**Assessment of Sixteen (16) Protected-Size Trees
at and adjacent to
62 Ellenwood Avenue
Los Gatos, California**

Prepared for:
Sean Mullin, Associate Planner
Town of Los Gatos Community Development Department
110 E. Main Street
Los Gatos, CA 95030

Report by CTA
6/3/2020

Walter Levison, Contract Town Arborist 6/3/2020
Markup of Sheet L0.0 Dated 4/23/2020 Showing
Sixteen (16) Protected-Status Trees
(Both on and Adjacent to the 62 Ellenwood Property)

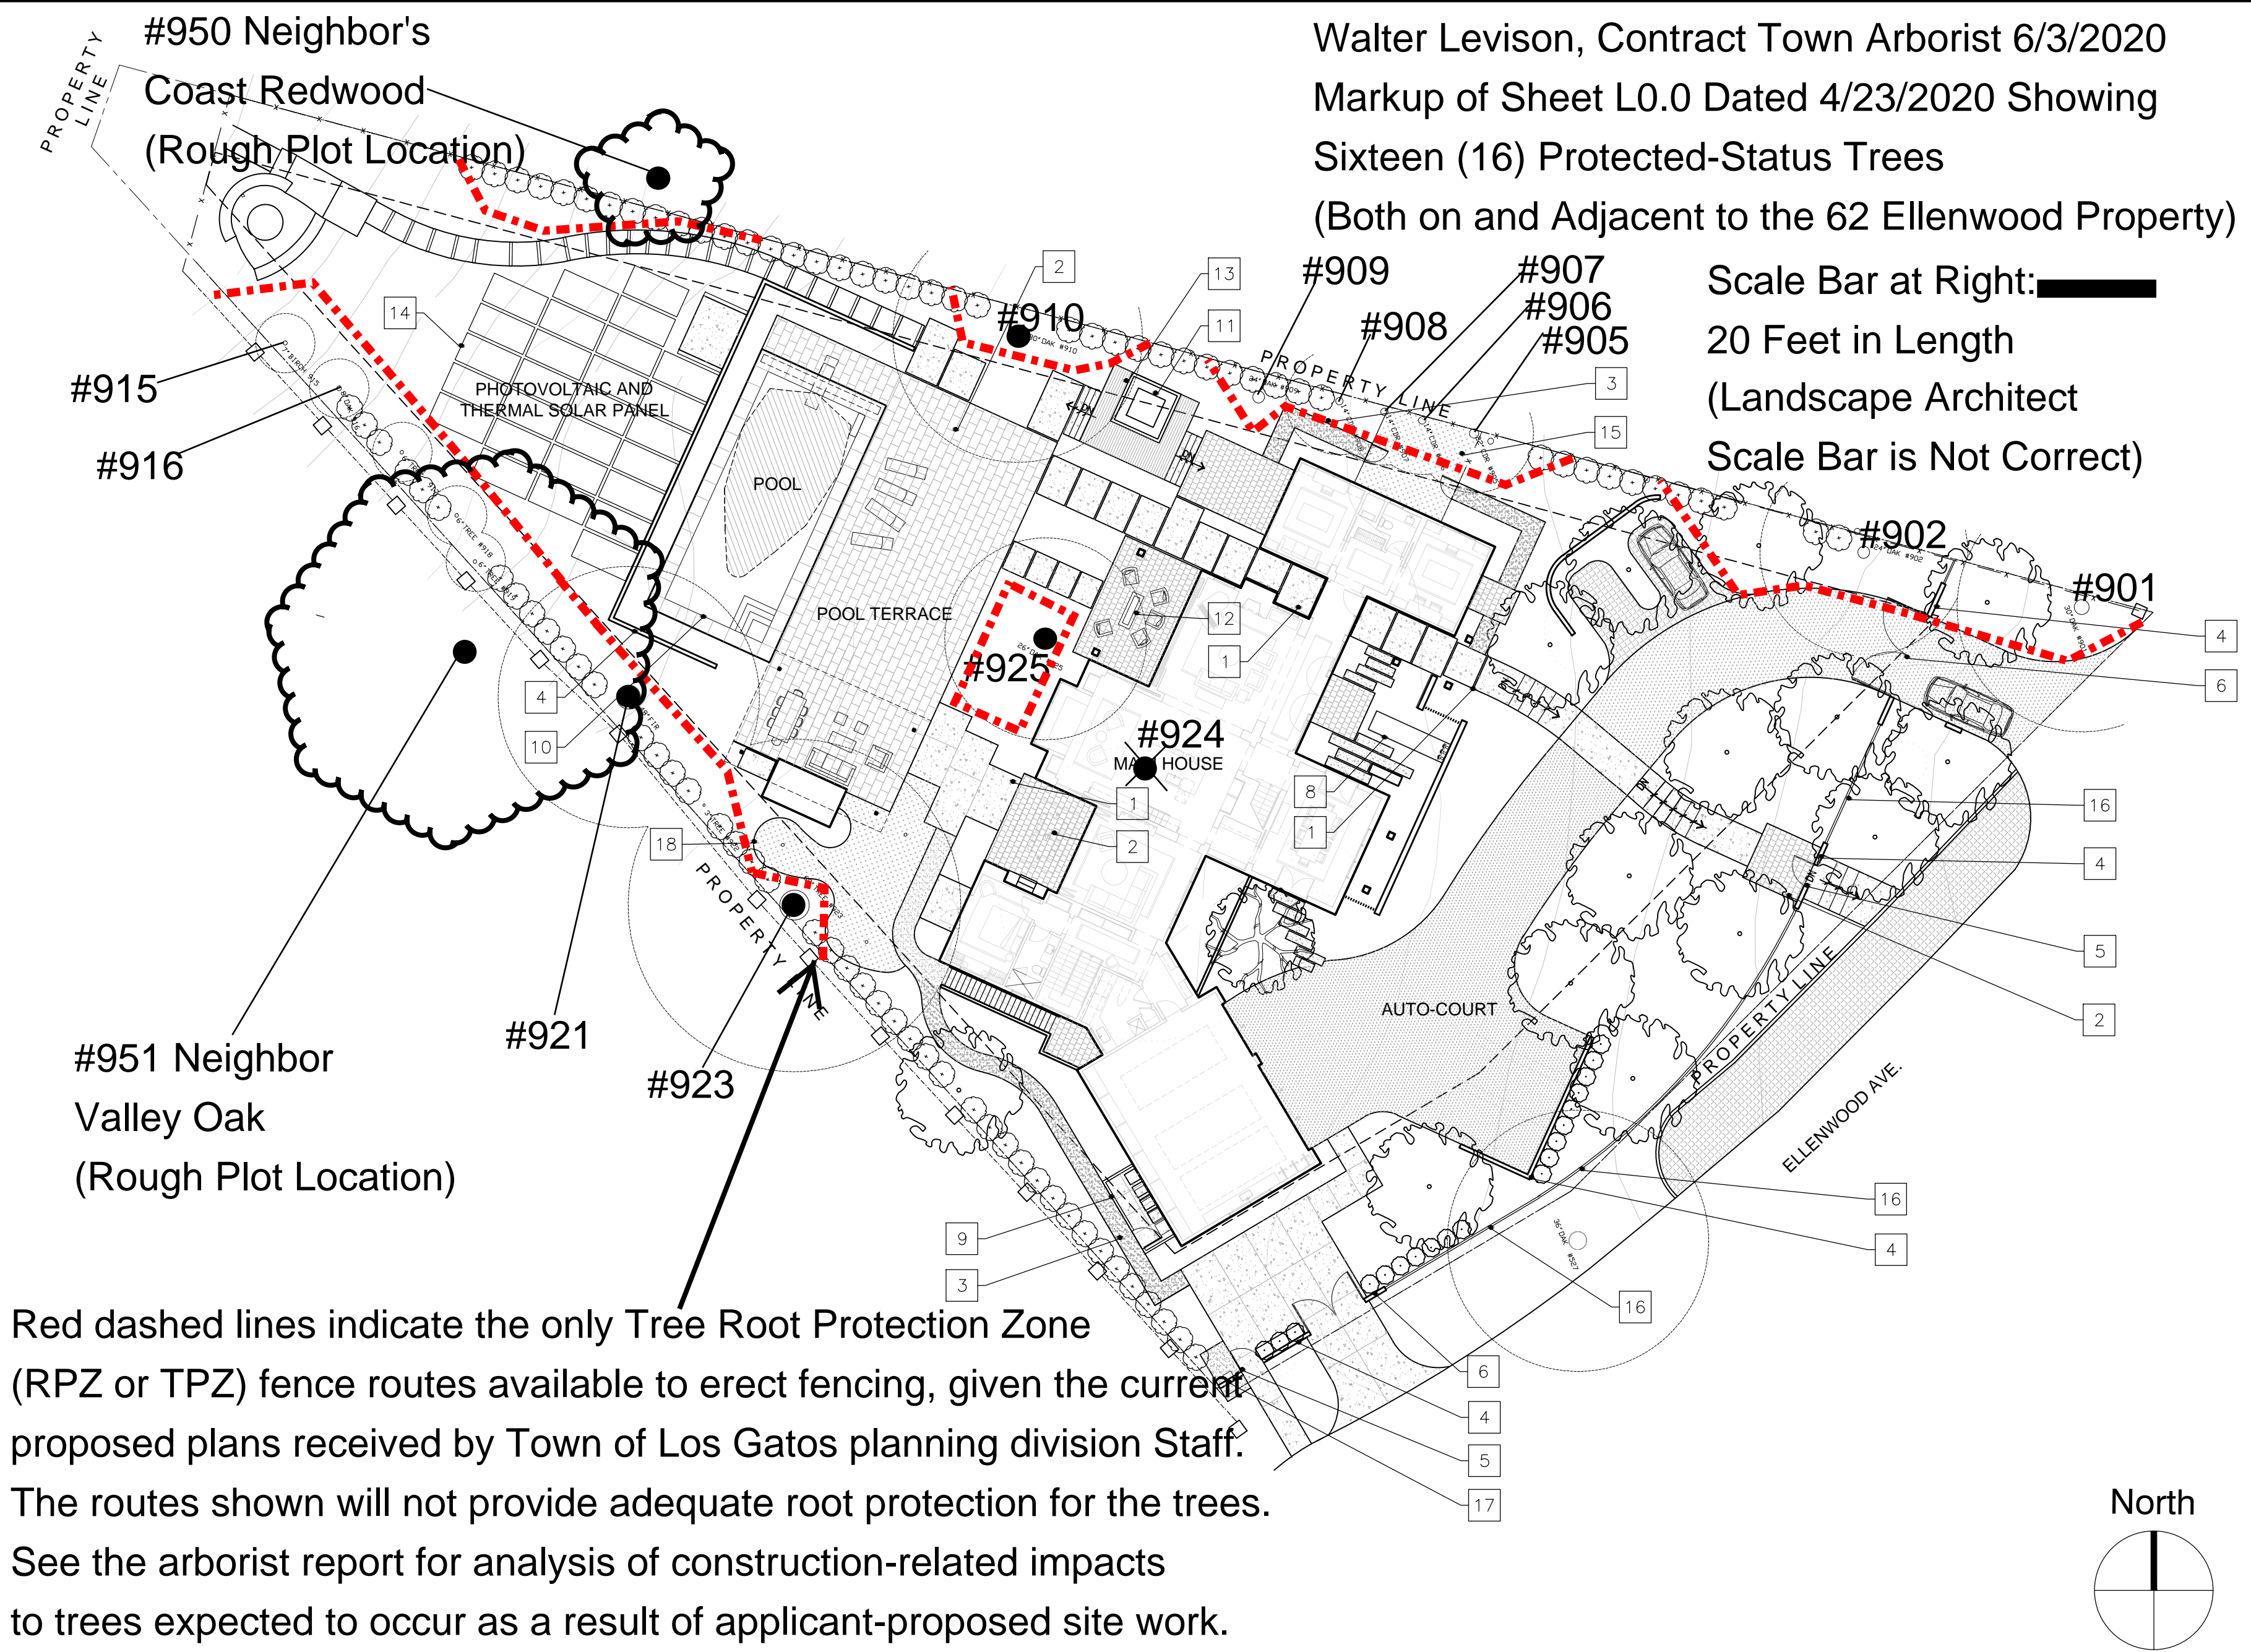
The CTA marked up the applicant’s sheet L0.0 dated 4/23/2020 which is an amalgamated proposed site plan/landscape plan sheet. This markup is attached to the end of this report as a PDF markup using Adobe Pro, and the markups by the CTA may not be visible unless the viewer opens the document using Adobe Pro or Adobe CS.

- c. Canopy driplines for the two neighbor trees were drawn out by the CTA to approximate scale, using black clouding.
- d. Red dashed lines indicate chain link fencing tree root protection zones or root protection zones (TPZ or RPZ). However, as noted by the CTA on the tree map markup, the current available locations for TPZ fencing are not adequate to allow for root preservation or protection, given the current proposed extent of site work indicated on the applicant’s set of plans dated 4/23/2020. Most of the “Critical Root Zone” minimum required construction offset distances for protection of trees’ structural root plates will be violated, if the proposed plans are built out as currently proposed by the applicant.

Red dashed lines indicate the only Tree Root Protection Zone (RPZ or TPZ) fence routes available to erect fencing, given the current proposed plans received by Town of Los Gatos planning division Staff. The routes shown will not provide adequate root protection for the trees. See the arborist report for analysis of construction-related impacts to trees expected to occur as a result of applicant-proposed site work.
